# **A G E N D A**

## **Architectural Review Board**

**July 28, 2015**

660 Cloverdale Road

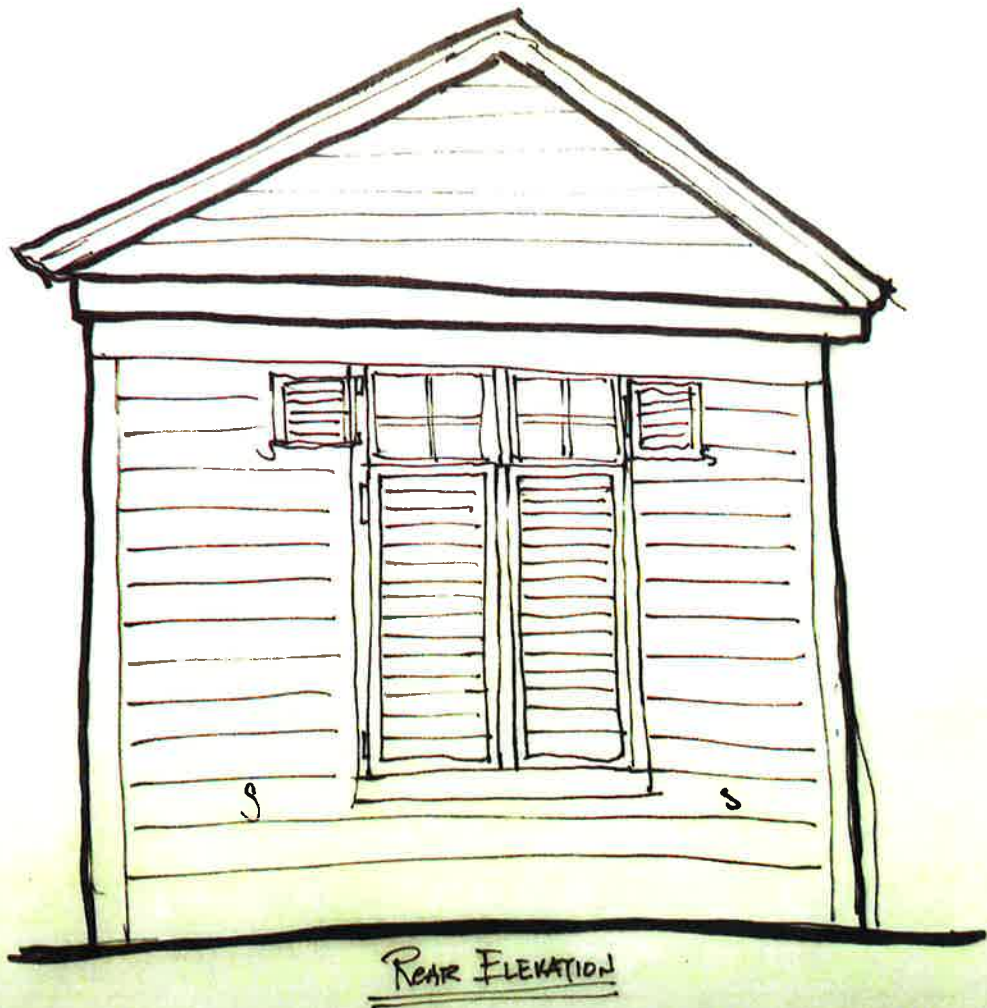
- When historic materials are approved for removal/replacement (doors, windows, etc), Staff recommends the owner consider donating the materials to Rescued Relics at Landmarks Foundation. Donations are tax deductible, contact Carole King at 240-4512 for more information.
- The petitioner is aware that any replacement outbuilding would require ARB review and meet all of the current zoning and building code setbacks and guidelines.

FRONT VIEW  
PROPOSED

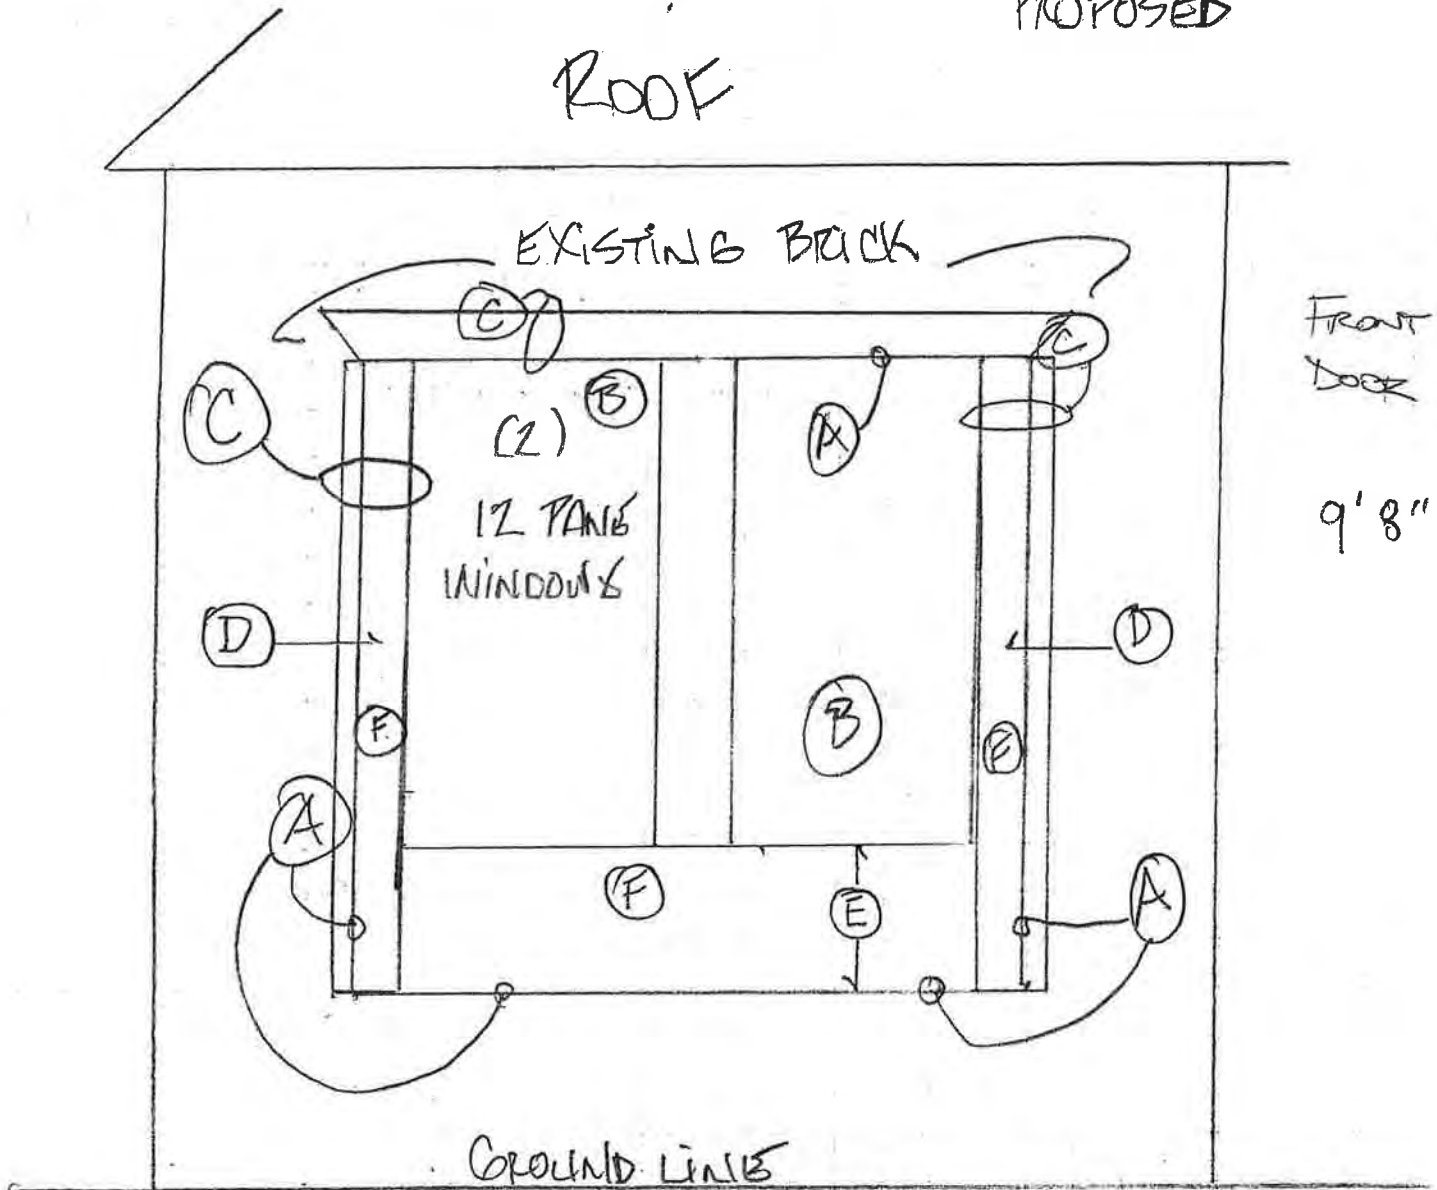
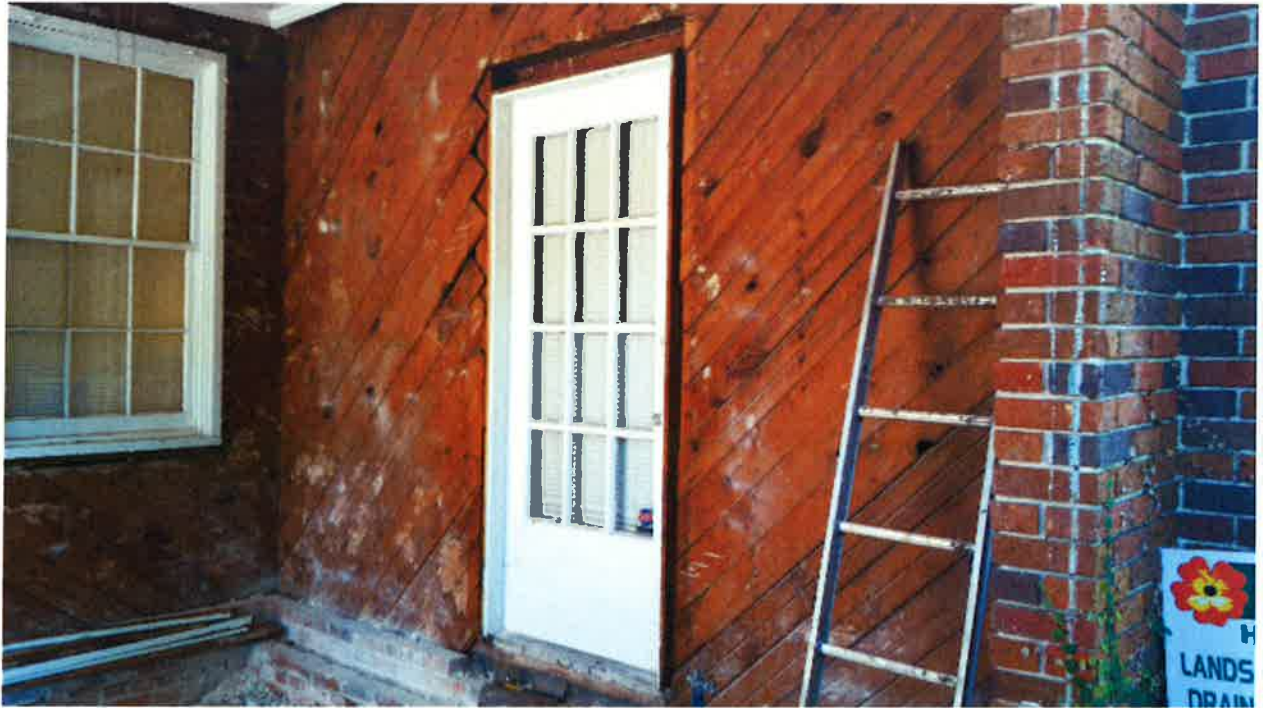
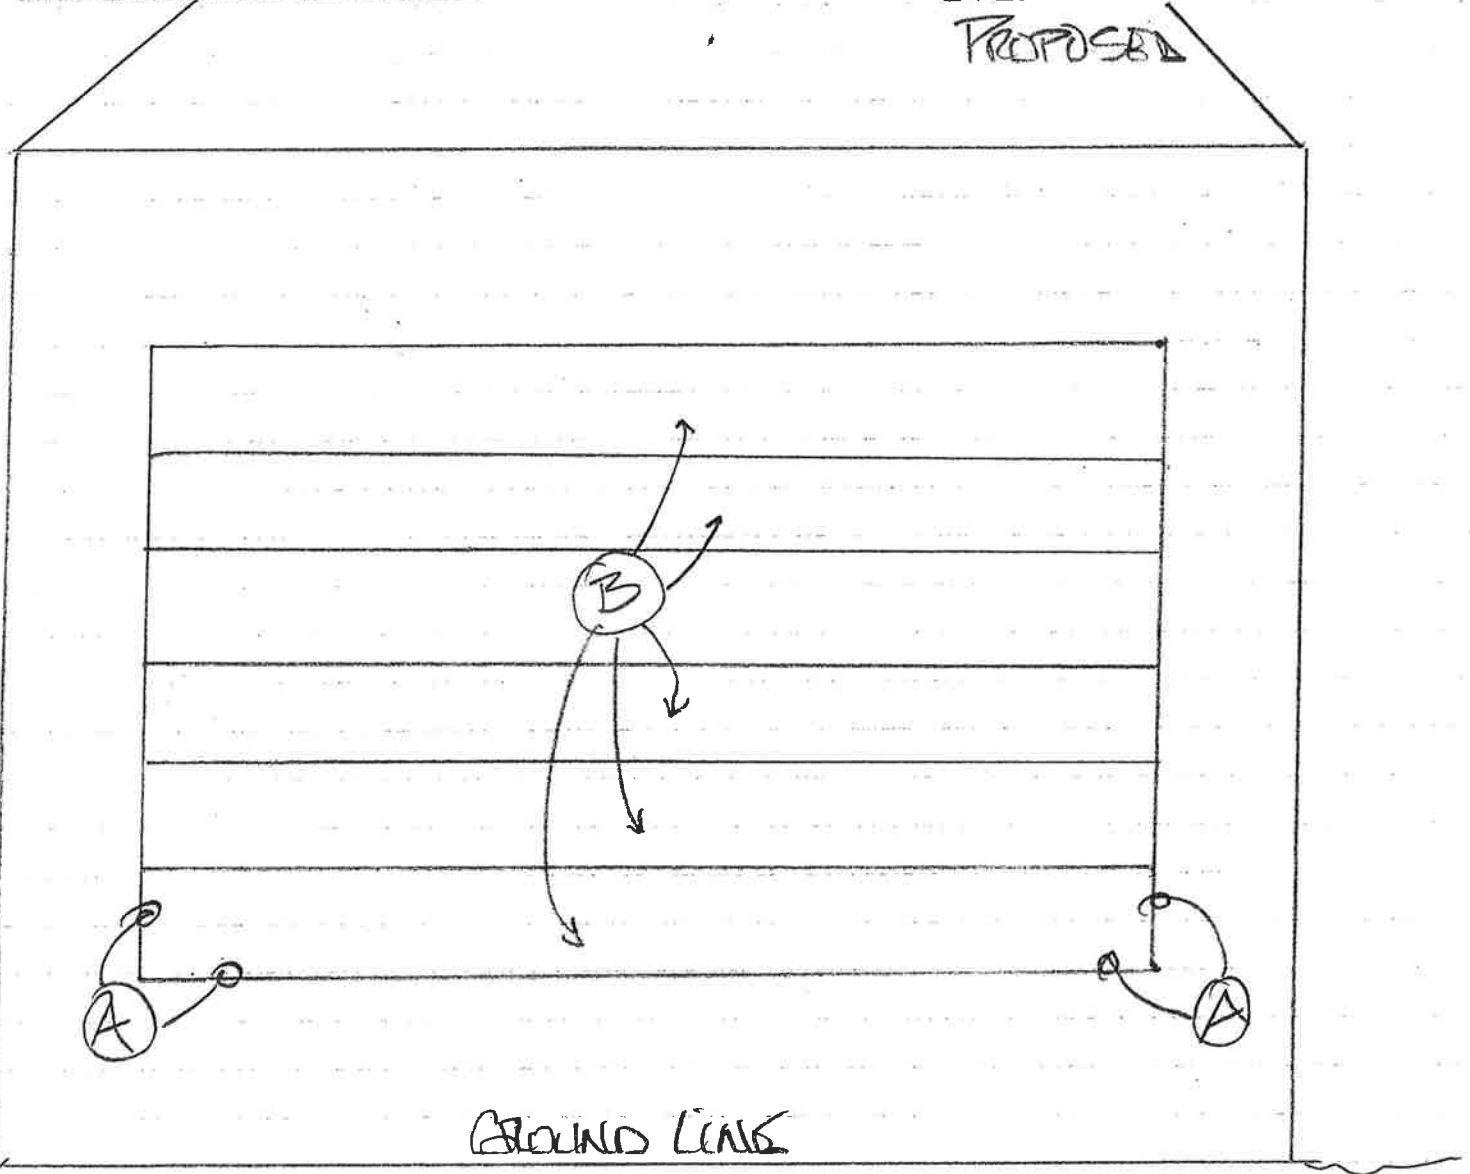
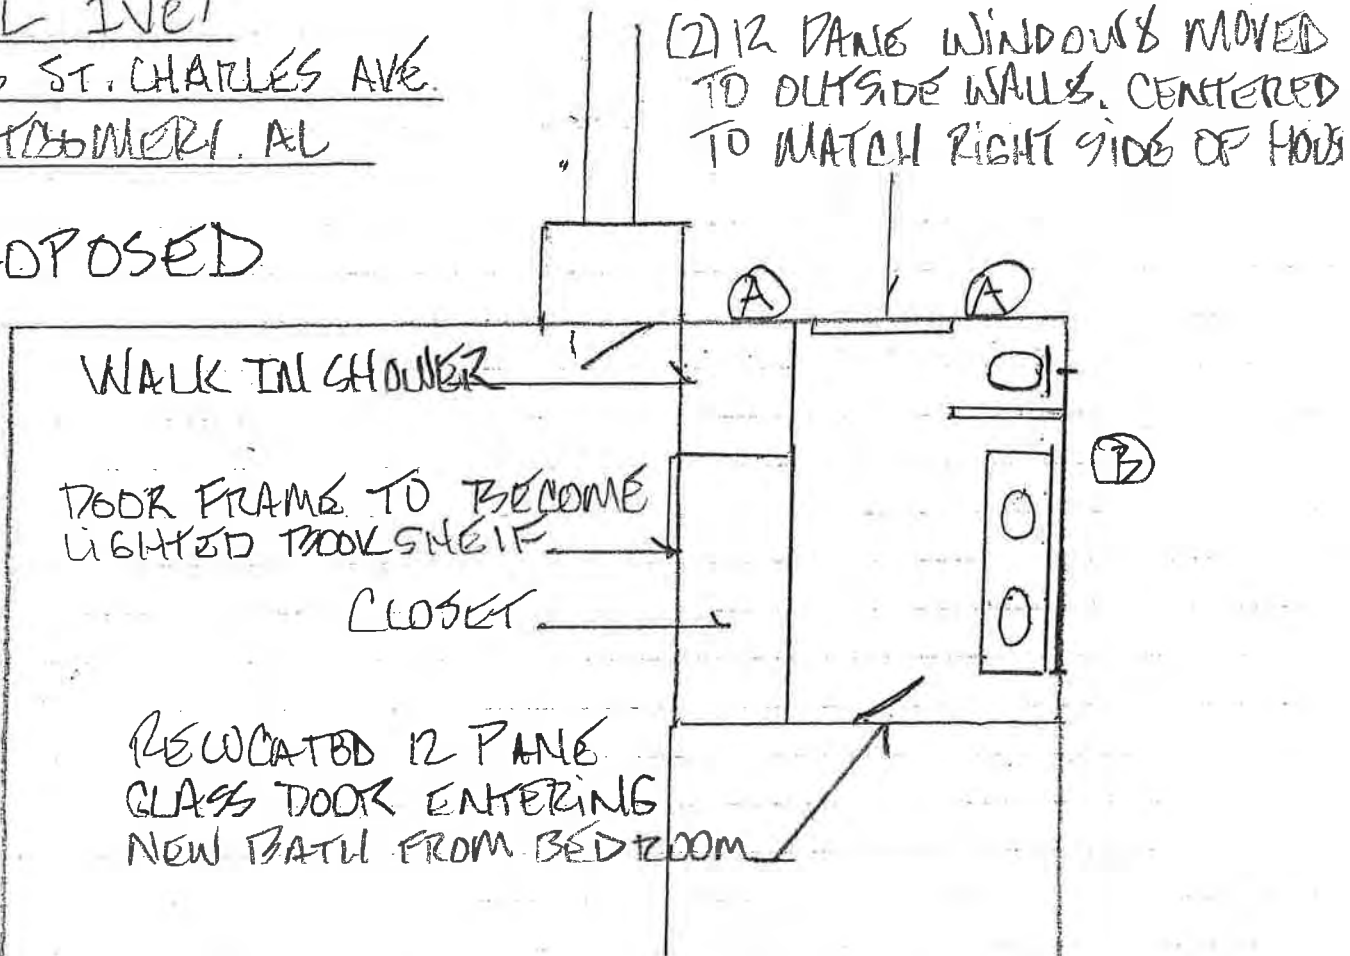
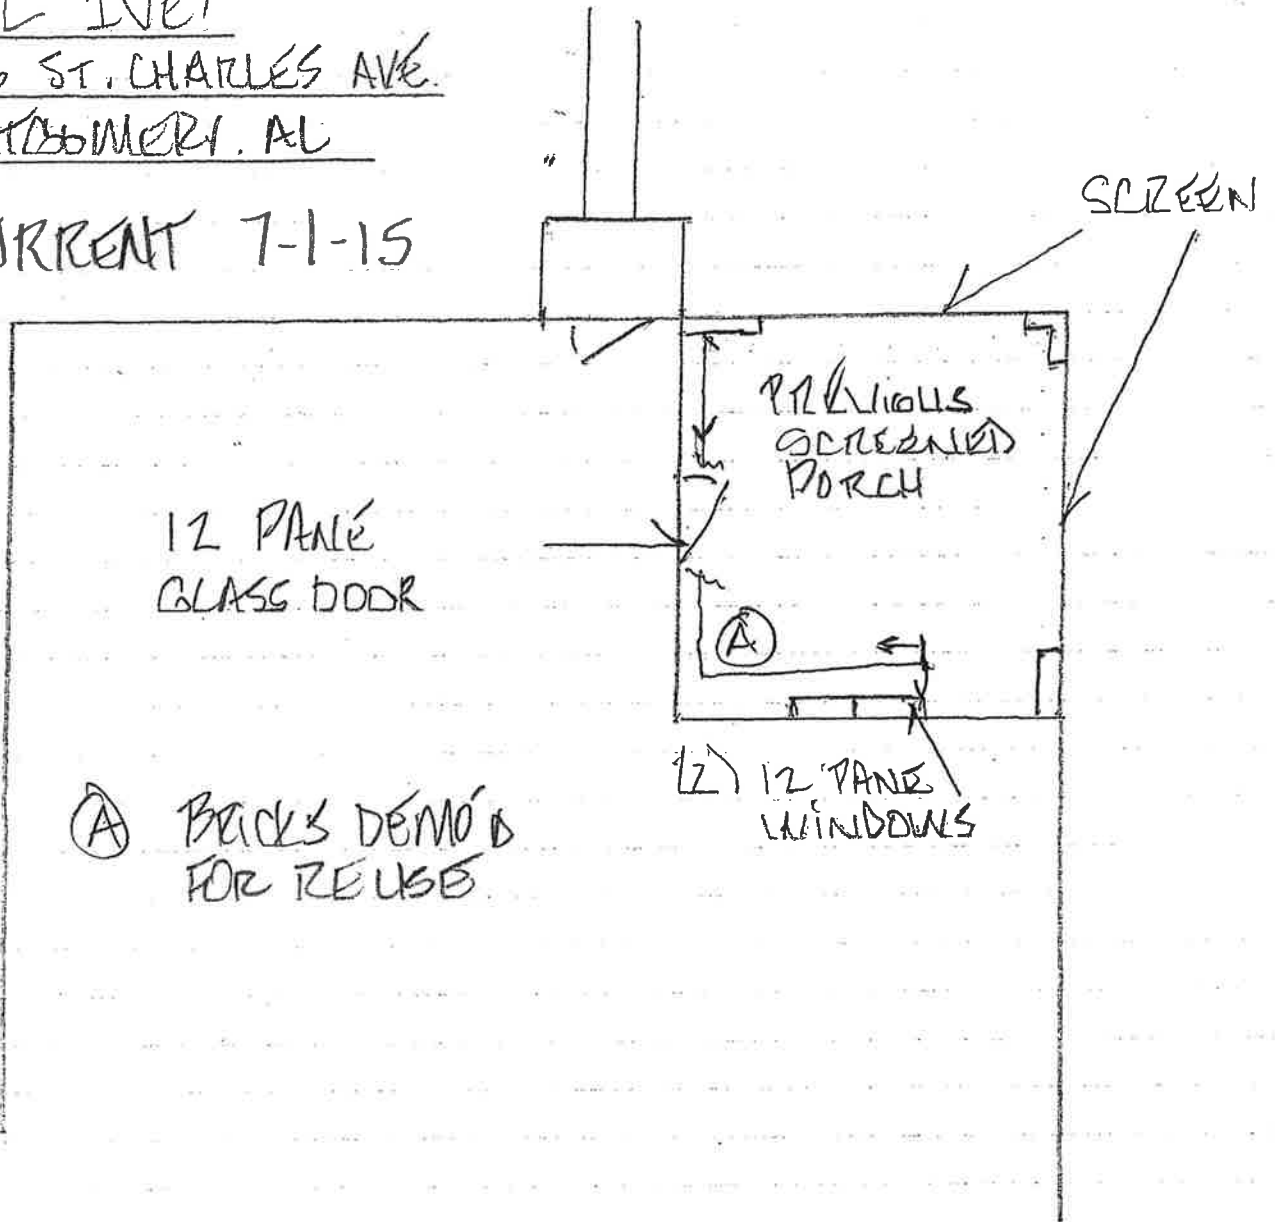
- Enclosing a front facing porch that is in line with the front of the house will alter the character of the house.
- The brick header on the porch opening is lower than the window header of the windows on the right side of the house. Consequently, installing windows in the existing opening would result in the new windows being lower than the existing windows.

1123 Magnolia Curve ROW

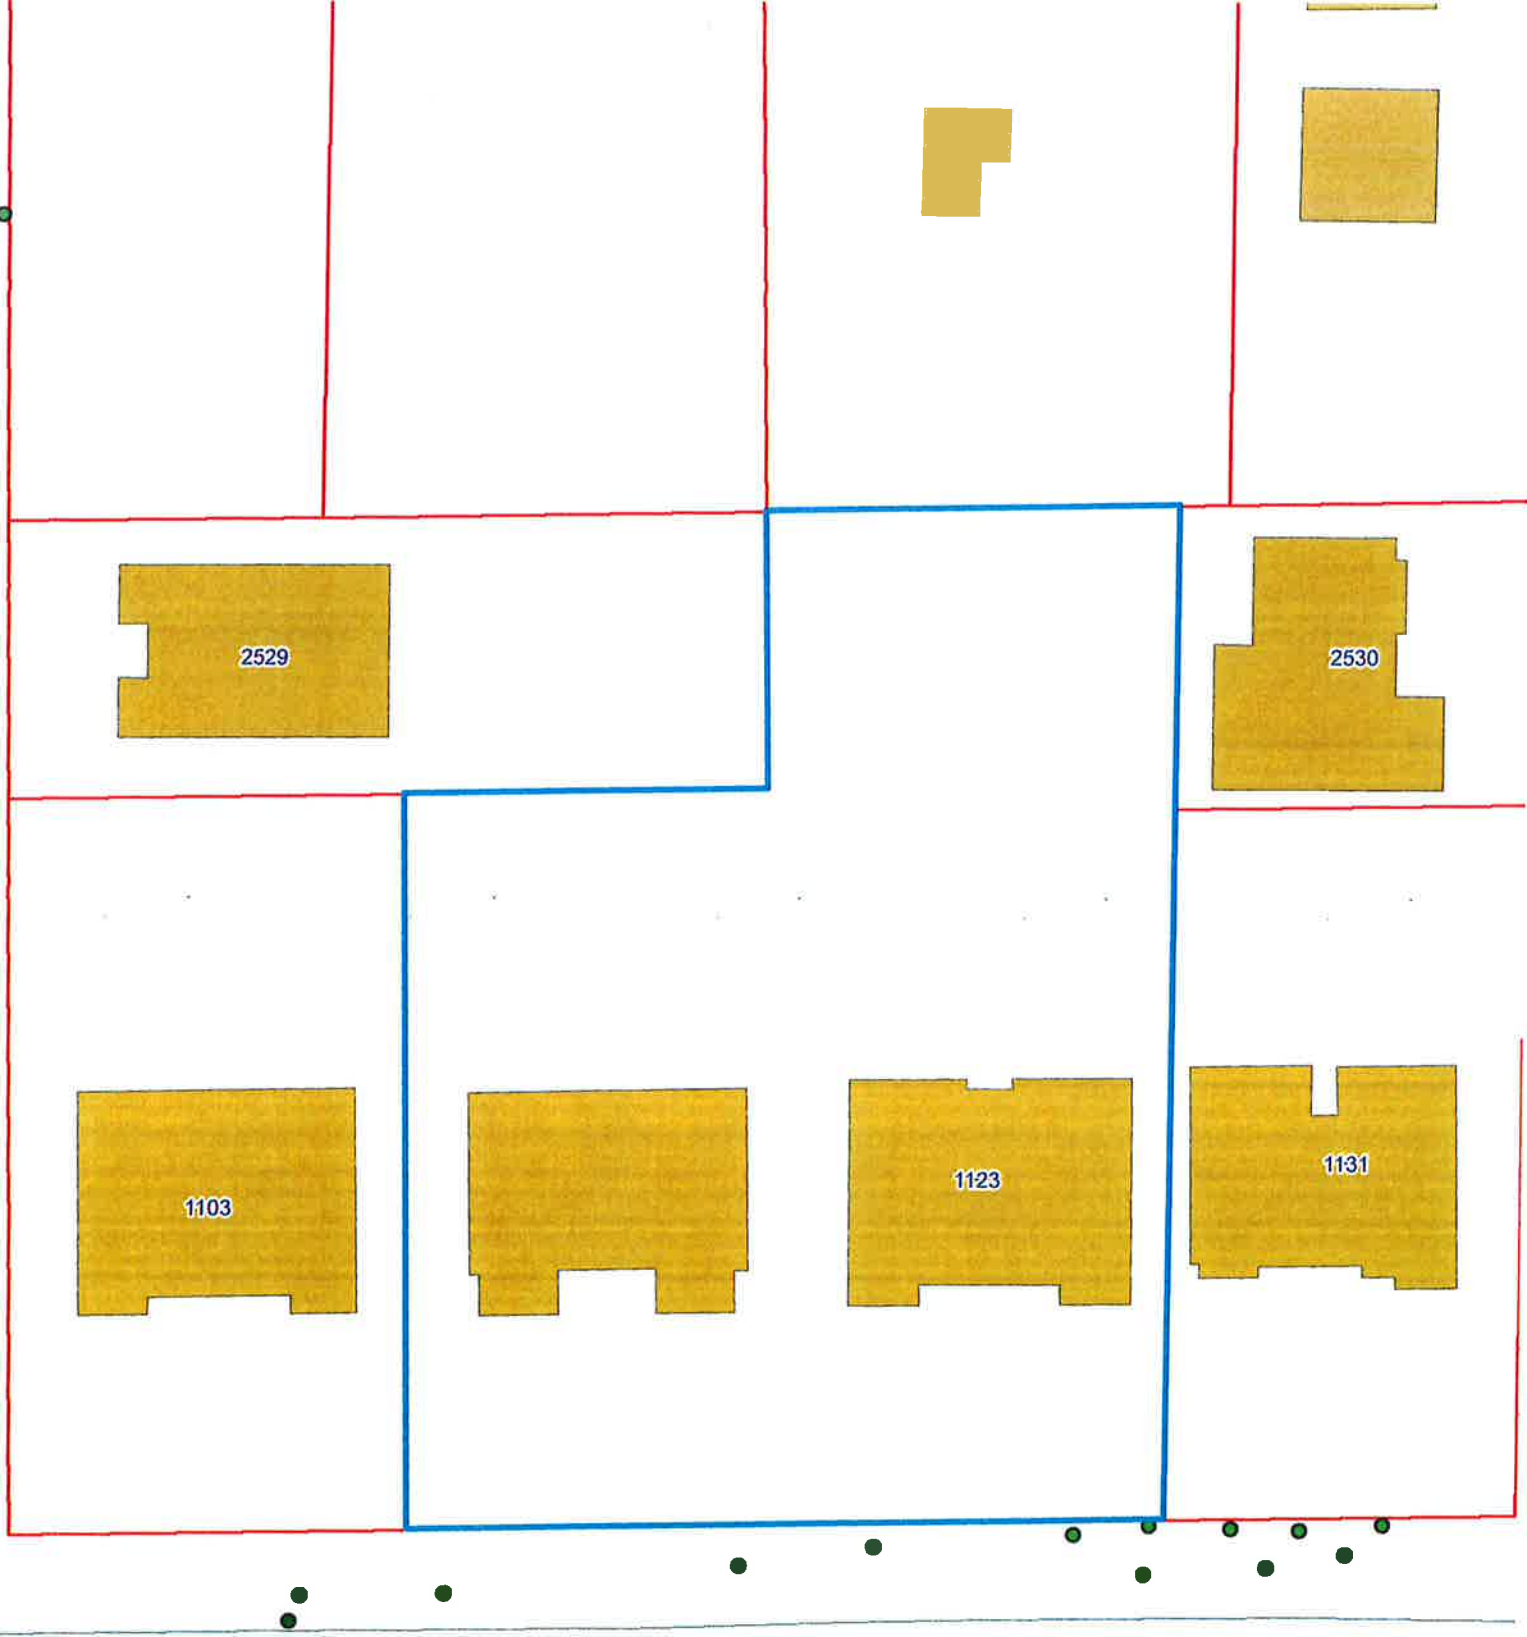
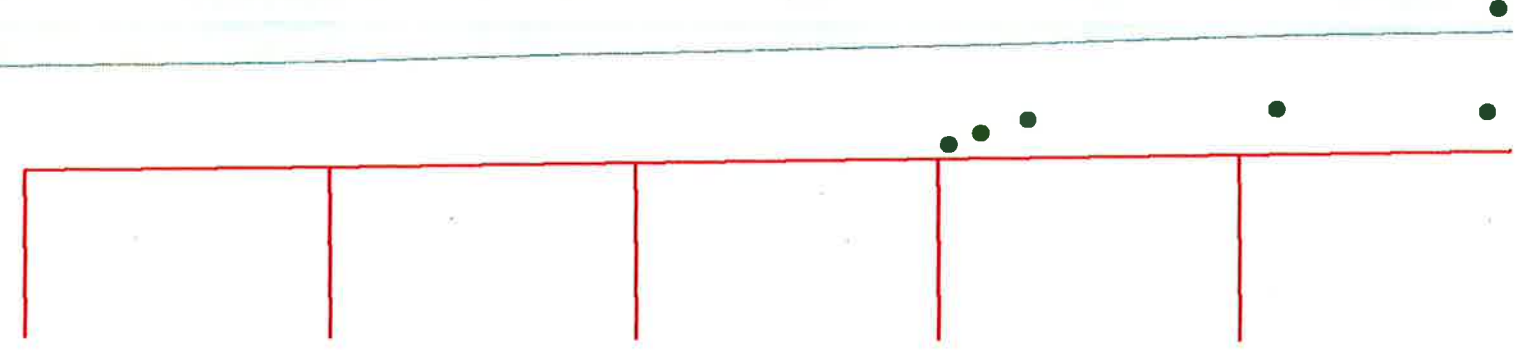
- The Urban Forester seems to have a bias against popcorn trees, which turn a lovely shade of red in the fall.
